CERTIFICATE OF APPROPRIATENESS

Property: 620 Columbia Street, Lot 17, Block 281, Houston Heights Subdivision. The property includes a historic 1,279 square foot one-story wood frame single-family residence and rear detached garage situated on a 6,600 square foot (50' x 132') interior lot.

Proposal: Alteration – Addition

WEST ELEVATION – FRONT FACING COLUMBIA STREET

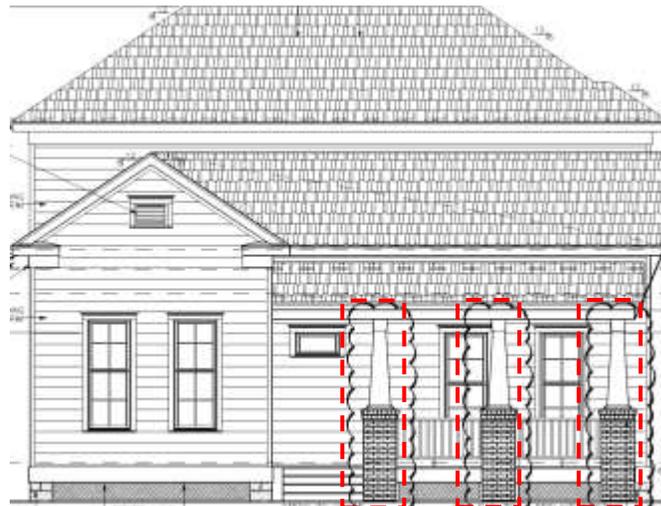
<i>The replacement of the existing 2-lite front door with the proposed craftsman style entry door and replacement of the turned columns with square tapered columns and brick bases significantly alters the character of the 1910 Queen Anne style residence.</i> |

<i>The removal of the existing wood turned columns and existing 2-lite entry door results in the loss of distinguishing qualities that contribute to the character of the 1910 residence.</i> |

<i>The replacement of the turned columns with square tapered columns with brick bases and replacement of the 2-lite front door with a 3-lite wood paneled front door results in the loss of significant stylistic exterior features that characterize the 1910 Queen Anne residence.</i> |

<i>The removal of the existing turned columns and entry door results in the significant loss of material that contributes to the character and integrity of the contributing residence.</i> |

Denial of: Replacement of the existing turned wood columns and 2-lite front entry door and installation of 1x12 band board on existing residence.

Denied: Replacement of existing turned wood columns and 2-lite front entry door and installation of 1x12 band board on existing residence.

NORTH SIDE ELEVATION

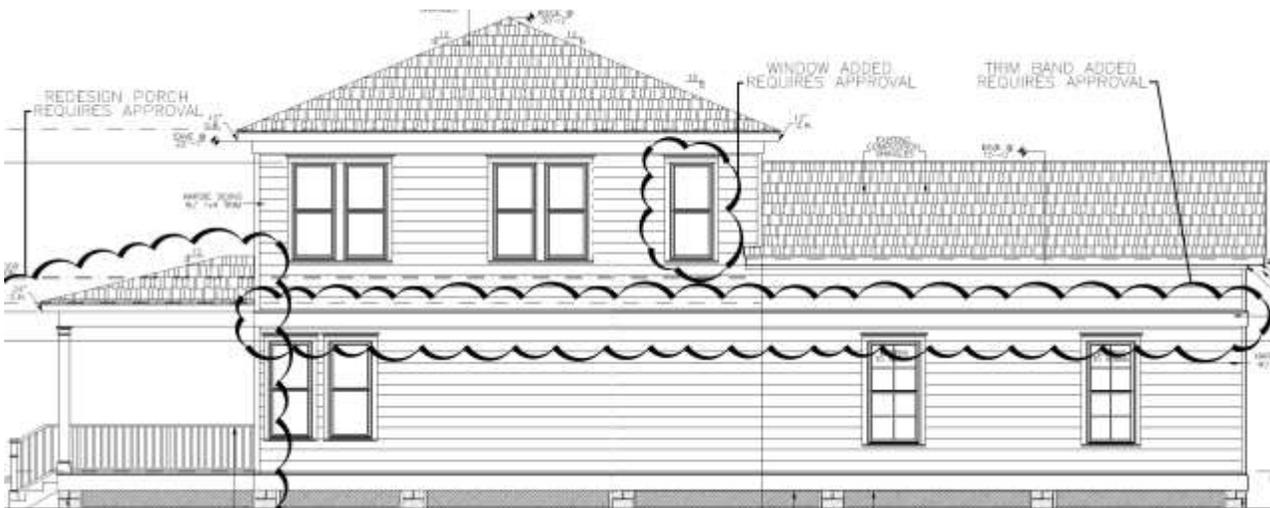
<i>The installation of the craftsman style entry door, square tapered columns, and 1x12 band board introduce architectural elements that were never present on the residence and are not compatible with the character of the 1910 Queen Anne residence. The installation of these features creates a false sense of history.</i> |

<i>The replacement of the existing front door and turned columns with a 3-lite front door and tapered columns with brick bases and the installation of the 1x12 band board on the existing residence introduce architectural elements that are typical of Craftsman style residence and not compatible</i> |

HAHC Action: Partially Approved With Conditions: Relocation and installation of windows and doors on proposed addition, increased depth of rear porch to 12' deep, and installation of 1x12 band board on the proposed addition with the condition that a vertical trim board be added on the north elevation where the 1x12 band board terminates to delineate the historic house and proposed addition.

EAST (REAR) ELEVATION

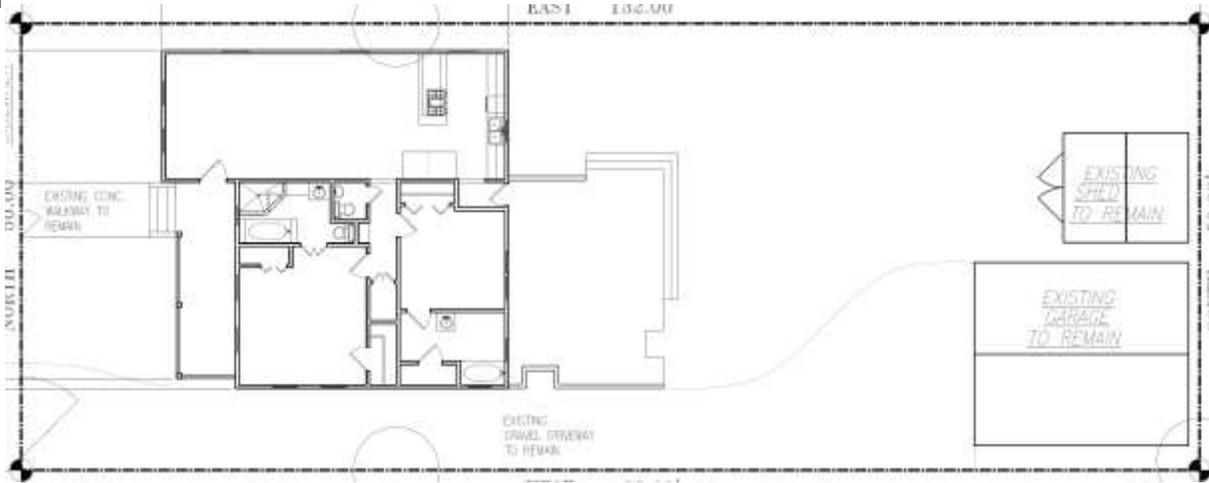
- Replace the three existing wood turned columns with square wood tapered columns with brick bases.
• Replace the existing 2-lite front entry door with a craftsman style, 3-lite wood paneled entry door.
• Install a 1x12 band board on the north, south and east elevations of the existing residence and proposed addition.
• Relocate and install windows on the north, south, and east elevations of the proposed 2-story addition.
• Change a proposed divided lite french doors and two 1-over-1 sash windows to three divided lite entry doors on the rear elevation of the proposed addition.
• Enlarge the proposed rear porch from 8' deep to 12' deep.
